## **DAUPHIN CREEK ESTATES SUBDIVISION**

The plat illustrates the proposed 29.0 ± acre, 6 lot subdivision which is located on the West side of Dauphin Island Parkway extending 120'± East of Eslava Creek, situated around Woodland Drive and Highland Court, and is in Council District 3. The applicant states that the site is served by public water and sanitary sewer facilities.

The purpose of this application is to create six legal lots of record from three metes-and-bounds parcels.

# DETAIL SITE PLAN

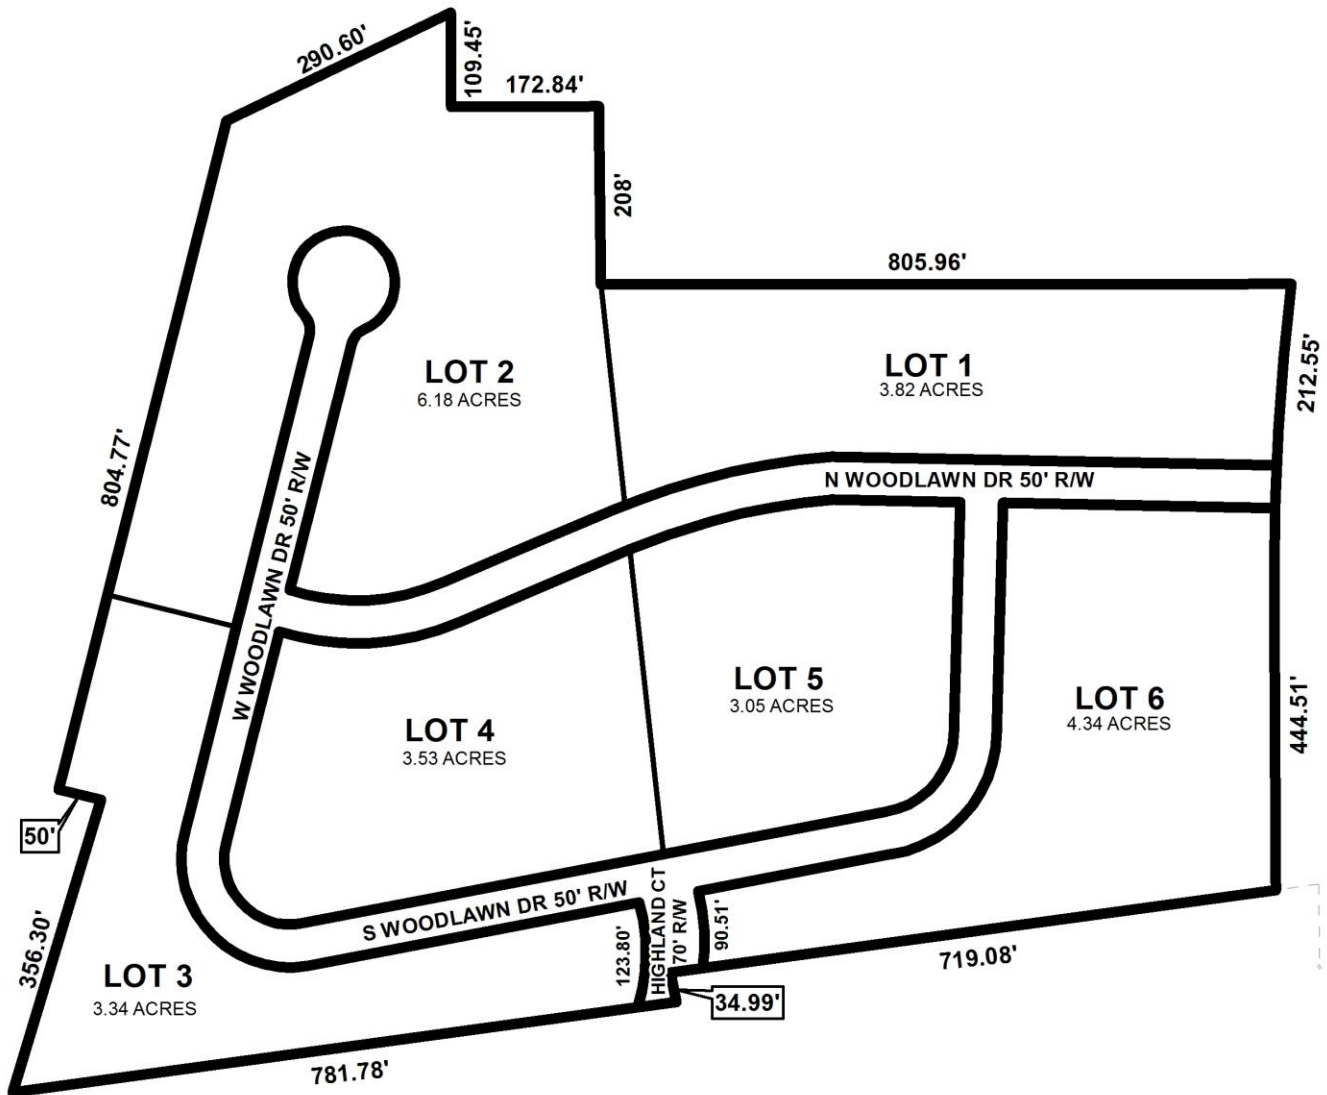
The site fronts Dauphin Island Parkway, a major street with a required right-of-way of 100', per the Major Street Plan. The preliminary plat does not depict Dauphin Island Parkway, nor does it identify the existing right-of-way. If approved, the Final Plat should be revised to illustrate either dedication to provide 50' from the centerline of Dauphin Island Parkway or the illustration of adequate existing right-of-way. The site also fronts Woodlawn Drive North, Woodlawn Drive West, Woodlawn Drive South, Woodlawn Drive East, and Highland Court, all minor streets with curb and gutters and are depicted as having 50' rights-of-way width, and a cul-de-sac. The depiction of the minor streets appears that the applicant may wish to convert them from public streets to private. If this is accurate, private street subdivisions require Planned Unit Developments; if this is not accurate, the plat should be revised to clearly indicate that the roads are intended to remain public. Dedication of the corner radii at all intersections should be provided per Section V.D.6. of the Subdivision Regulations, if approved.

The 25' minimum building setback lines are not depicted along any frontages. If approved, the Final Plat should be revised to illustrate the 25' minimum building setback from all frontages.

The lot sizes in both square feet and acres are depicted on the preliminary plat and should be retained on the Final Plat, if approved.

- 1) depiction of Dauphin Island Parkway, and either dedication to provide 50' from the centerline, or illustration the there is adequate existing right-of-way;

- 2) clearly indicate if Woodlawn Drive North, Woodlawn Drive West, Woodlawn Drive South, Woodlawn Drive East, and Highland Court are private or public streets;

- 3) illustration of the 25' minimum building setback line from all frontages;
- 4) dedication of the corner radius at the Northwest and Southwest corners of Dauphin Island Parkway and Woodlawn Drive North per Section V.D.6. of the Subdivision Regulations;

- 5) dedication of the corner radius at the Southwest and Southeast corners of Woodlawn Drive East and Woodlawn Drive North per Section V.D.6. of the Subdivision Regulations;

- 6) dedication of the corner radius at the Northwest and Southwest corners of Woodlawn Drive West and Woodlawn Drive North per Section V.D.6. of the Subdivision Regulations;

- 7) dedication of the corner radius at the Southwest and Southeast corners of Woodlawn Drive South and Highland Court per Section V.D.6. of the Subdivision Regulations;

- 8) retention of the right-of-way widths of Woodlawn Drive North, Woodlawn Drive West, Woodlawn Drive South, Woodlawn Drive East, and Highland Court;
- 9) retention of the lot sizes in square feet and acres;
